From: Wagner, David B (PDS)
Sent: Tuesday, July 07, 2015 4:29 PM
To: 'Kathy Linares'; Tony Kelly; Markert, Tammy O; Liu, Emily
Cc: Pat Barry; David Johnson; David Mindel; Bill Bardenwerper; Jim Frey ; Boz, Milana A; Kevin Beck
Subject: RE: Brentwood Commons #15ZONE1015

After further discussion with PDS colleagues, we still believe the direct path connection should be provided. Therefore, a Waiver request will need to be filed and I will add that request to the notices for the 7/23/15 LD&T meeting. Please revise the plan (and submit the required application and documents) by adding the following list:

DETAILED DISTRICT DEVELOPMENT PLAN
BRENTWOOD COMMONS
 10509 BARDSTOWN BLUFF RD.
 LOUISVILLE, KY 40291
 TAX BLOCK: 61 LOTS: 87, D.B. 9212 PG. 904

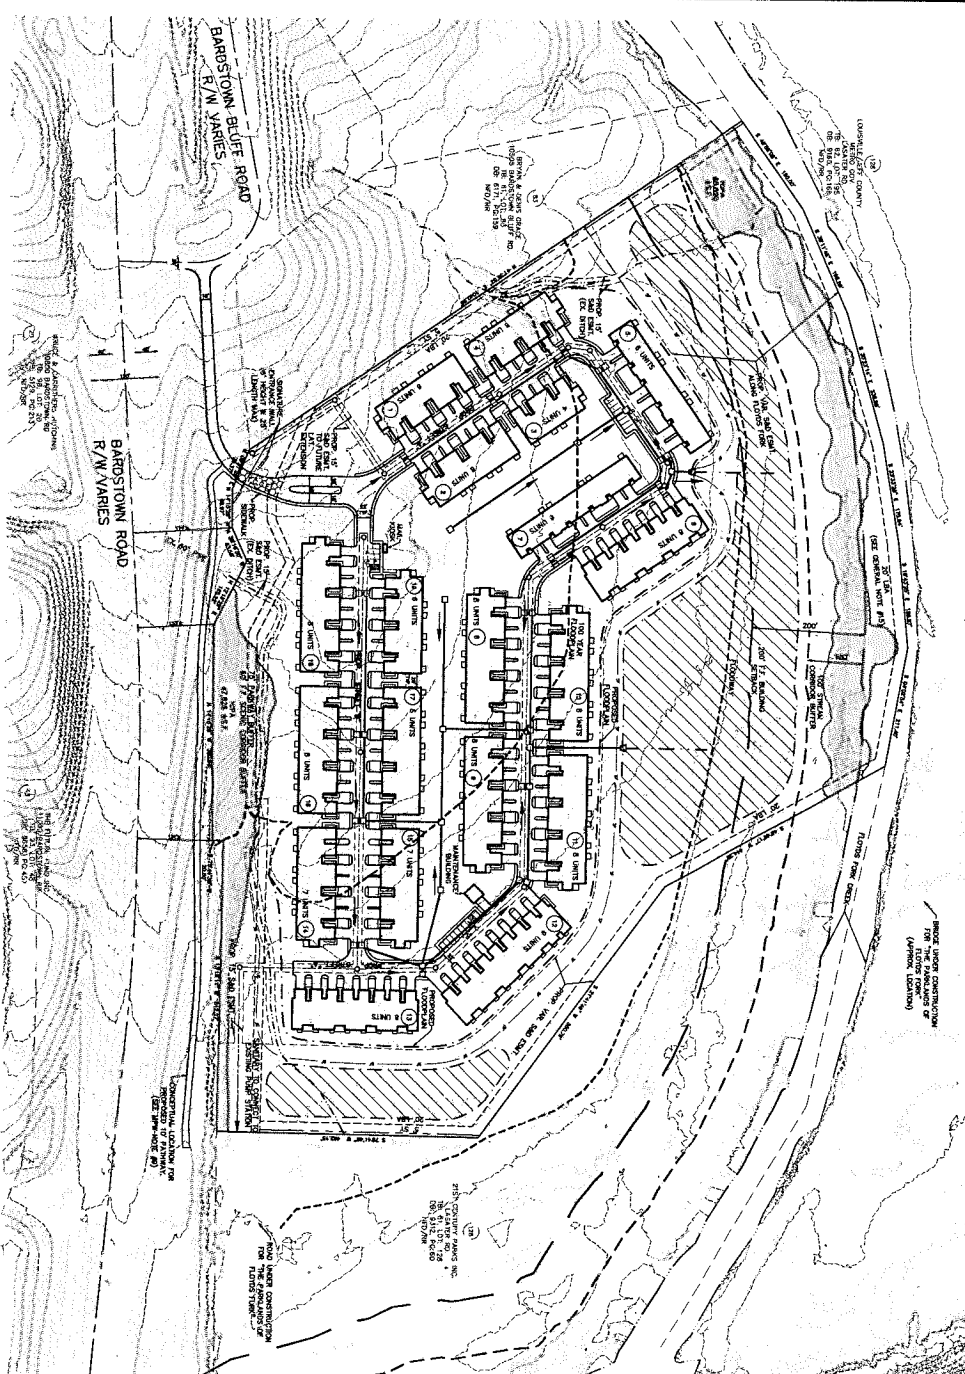
David and I reviewed the Brentwood Commons site this morning. More specifically the proposed detention volume provided. We request that you provide runoff volume compensation in the flood plain for this site instead of the detention basin as shown. Please feel free to call with any additional questions.

Just wanted you all to have access to the plan we refiled today to expedite review and further discussion if needed. Some of the changes included:

- Showing a detention basin to be located in the center of the building area and revised MSD notes accordingly
- Identified floodplain compensation area
- Eliminate PW note #8 regarding improvement to Bardstown Bluff Rd (as requested by Tammy/Jeff)
- Revised PW note #9 (was #10)10 regarding developer providing/constructing Louisville Loop across front of site
- (did not add note regarding direct connection along our shared property line with the park, since 21CP did not support it)
- Revised TCPA area and updated in Tree Canopy Data

We have revised the plan to remove the detention basin (accordingly update relative storm system and notes) and to reconfigure the north end of the 10' path along our frontage as suggested by Metro Parks. A pdf of this plan is attached. New plans will be filed/delivered today to PDS.

DETAILED DISTRICT DEVELOPMENT PLAN
BRENTWOOD COMMONS
 10509 BARDSTOWN BLUFF RD.
 LOUISVILLE, KY 40291
 TAX BLOCK: 61 LOTS: 87, D.B. 9212 PG. 904

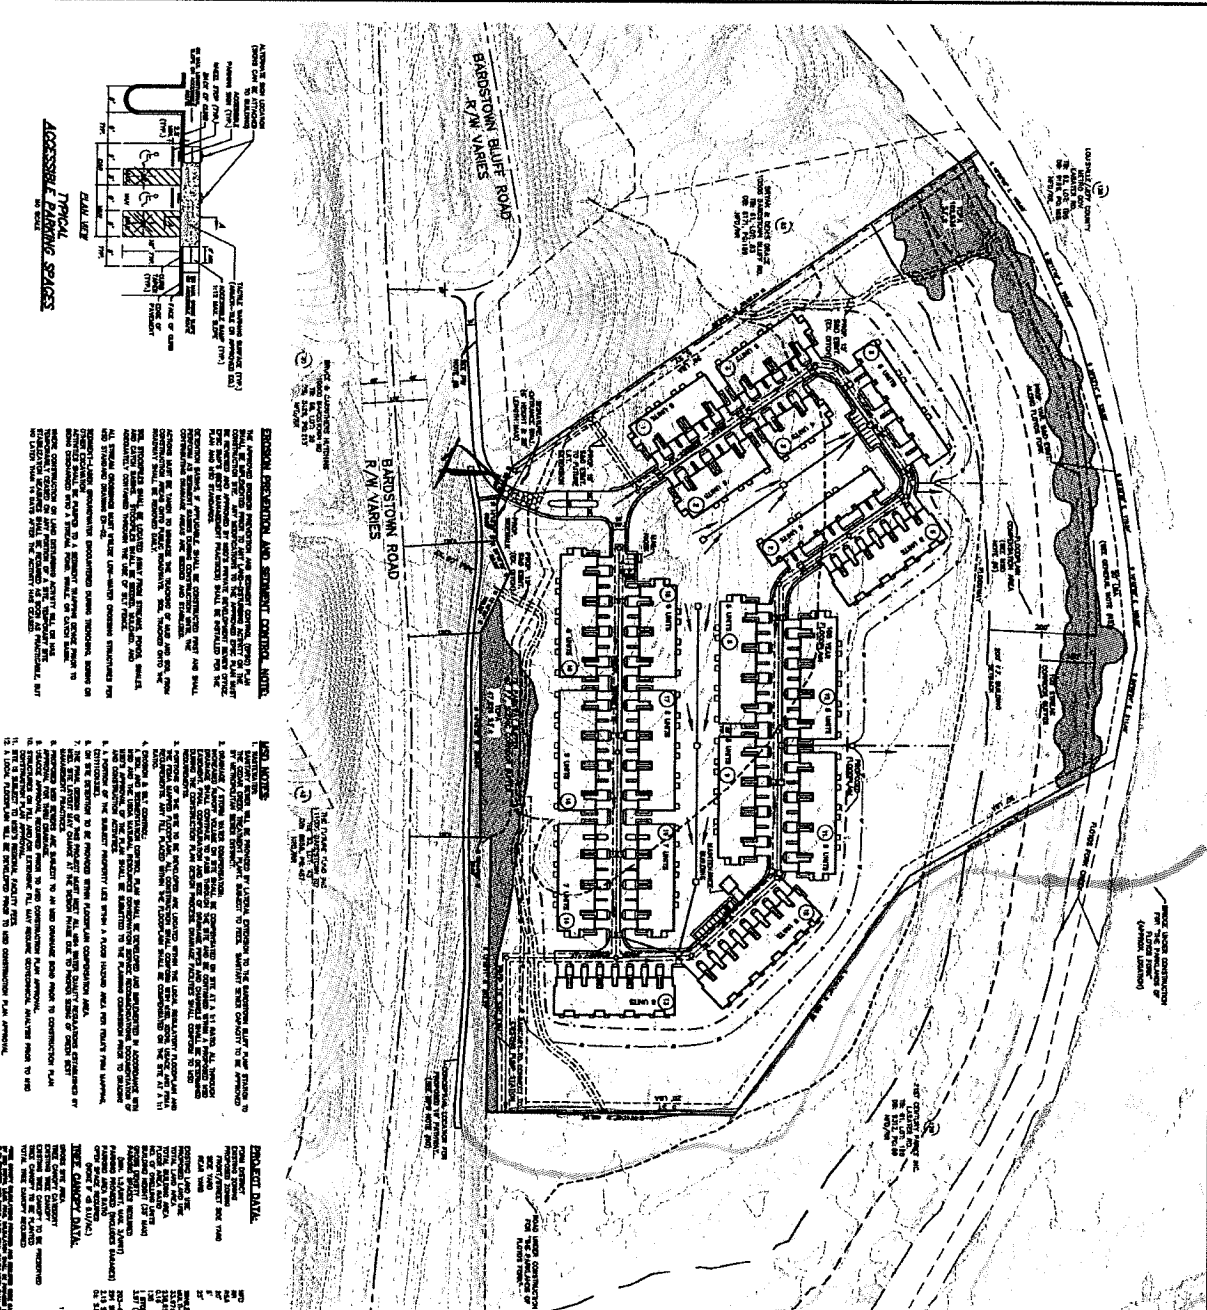
The attachment shows the big picture that the proposed development is connecting to what will be the Louisville Loop (yellow, purple and green line). Residents of the development will eventually be able to access the Loop and take it south into the Parklands of Floyds Fork or go north when Metro builds more of it (21st CP is only committed to construction and maintenance of Louisville Loop on our current existing properties).

The red line on the attachment is our shared property boundary.

The developer (as we've been told) is committing to build the yellow section to Loop standards (within the Bardstown Road ROW). 21st CP is NOT committing to either build nor maintain this as it is not on our current park property.

21st CP would rather the development NOT have a pedestrian access across our (red on the attachment) shared property line.
